REPORT TO: Heritage Kitchener

REPORT NO.: DSD-2022-450

SUBJECT: HPA-2022-V-027
Victoria Park Boathouse
Proposed Alterations, New Addition and Patio

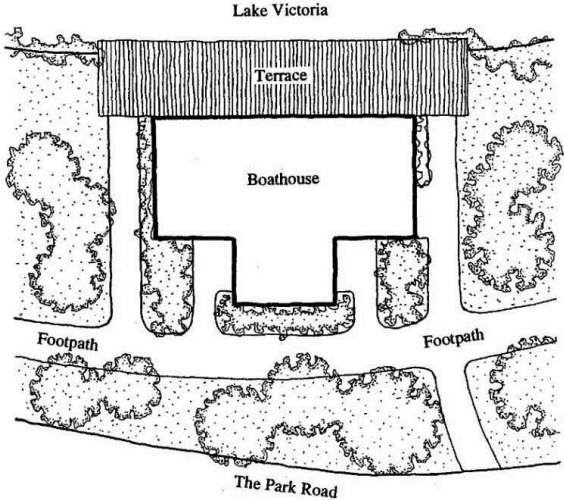
A scoped Heritage Impact Assessment (HIA) dated September 23, 2022, and revised October 7, 2022, was required to assess the impacts of the proposed development on the Boathouse and the surrounding landscape. The scoped HIA provided a history of the existing Boathouse, outlined the proposed development and assessed the impacts of the proposed development against the *Standards and Guidelines for Conservation of Historic Places in Canada* (Attachment B) and the VPAHCD Plan. The HIA made several recommendations that have been incorporated in the proposed redesign of the site. Some of the conclusionary remarks made in the HIA include:

- *Proposed enlargement of the existing rear façade openings will offer a new view from the Boathouse, this creates a middle ground of the exiting foreground and lake in the background.*

- *The proposed washroom additions and alterations do not negatively impact the existing views to the Lake and the commons from David Street, Roland Street, and Park Street (Jubilee Drive);*

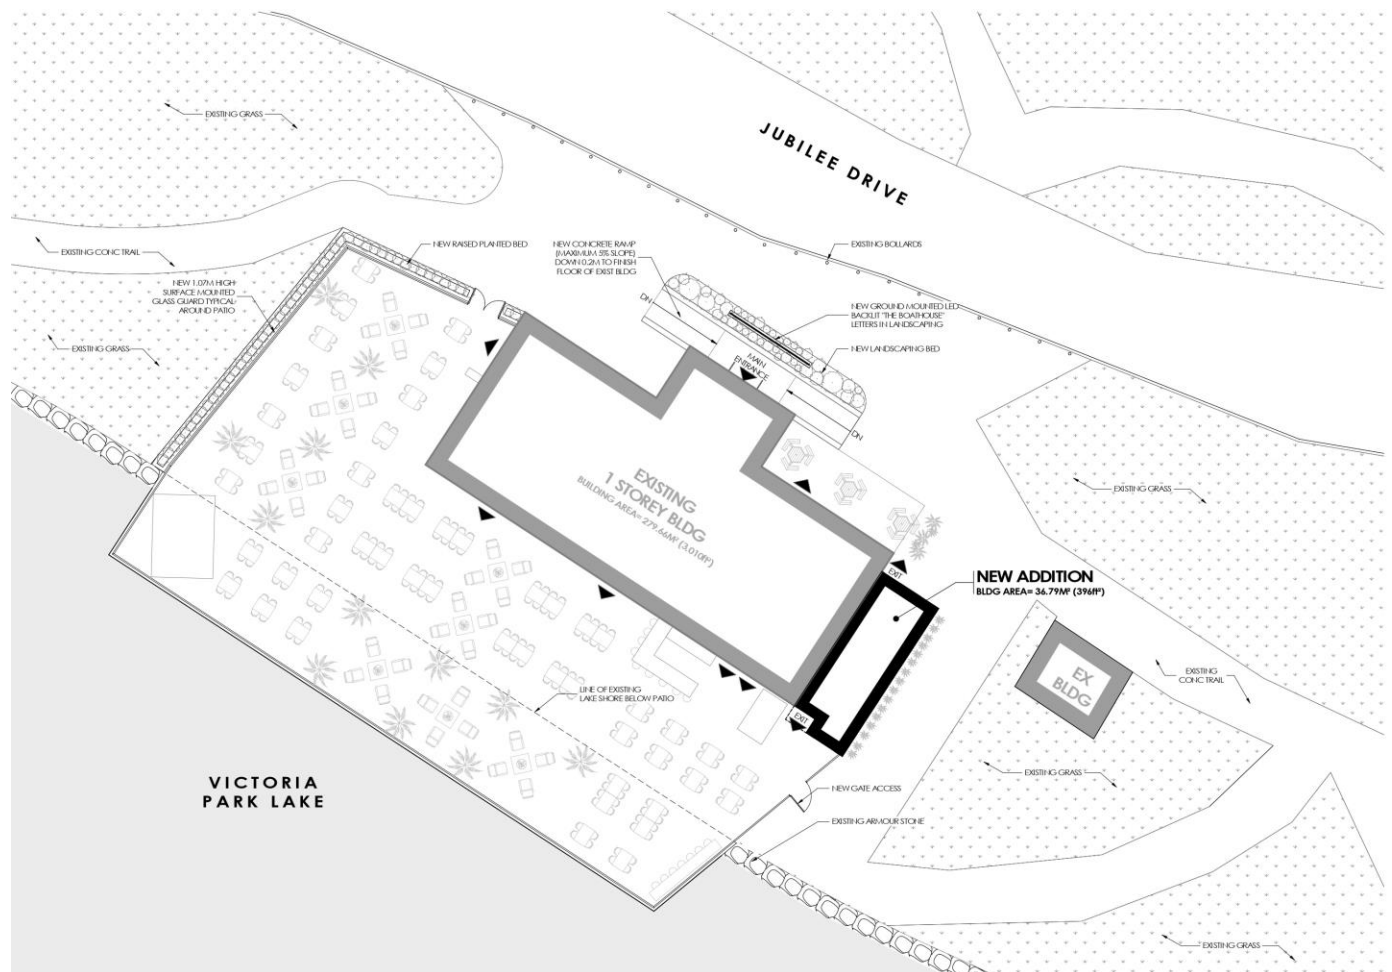
VPAHCD Plan Guidelines/Policy	Conformity of the Proposed Development
<p><i>Victoria Park Lake</i></p> <p><u><i>Conservation Guideline:</i></u> <i>The lake should be conserved as an open, uninterrupted body of water.</i></p> <p><i>Signage:</i></p> <p><u><i>Conservation Policies:</i></u></p> <ol style="list-style-type: none"> <i>1. Signage style shall be simple and direct and contribute to and enhance the naturalistic park character.</i> <i>2. Signage shall be discreet and inconspicuous while effective</i> 	<p>The proposed cantilevered deck will extend from the Boathouse above over the water. However, no structural infrastructure is proposed be installed in the lake to support the deck, ensuring that it is conserved as an open, uninterrupted body of water.</p> <p>Furthermore, the cantilevered patio would be a reversible design intervention, which could be removed in the future, if necessary, without having an adverse impact on the lake.</p> <p>The proposed signage uses traditional and simple materials like wood, which would enhance the naturalistic park character. The signage will be discreet, with ground mounted lighting and the colour palette will be coordinated with other painted features in the Park. The proposed signage will also</p>

<p>3. <i>A classic forest green colour, which is historically appropriate, shall be considered as the base background colour</i></p> <p>4. <i>Signage colour palette shall be coordinated with all other painted features in the Park.</i></p> <p>Vistas</p> <p><u><i>Conservation Guideline:</i></u> <i>The following intermittent vistas in the Park should be conserved and enhanced:</i></p> <ul style="list-style-type: none"> <i>• The sequence along the Park Road (Jubilee Drive) in both directions, including views to the Commons and Lake; and</i> <i>• Views from David Street and Roland Street to the Commons and Victoria Park Lake</i> 	<p>be compatible with the overall Romantic Landscape of the Park.</p> <p>There will no impact on the existing views and vistas.</p>
<p><i>Building Addition Policies</i></p> <p><i>Location – Additions shall be located to the rear or rear side of the existing historic building so as to maintain the original principal façade as a visual entity. Where additions are brought forward, they shall not visually dominate or overpower the existing historic building.</i></p>	<p>The proposed addition is located on the rear side of the east façade of the existing building, thus maintain the principal façade as a visual entity.</p>
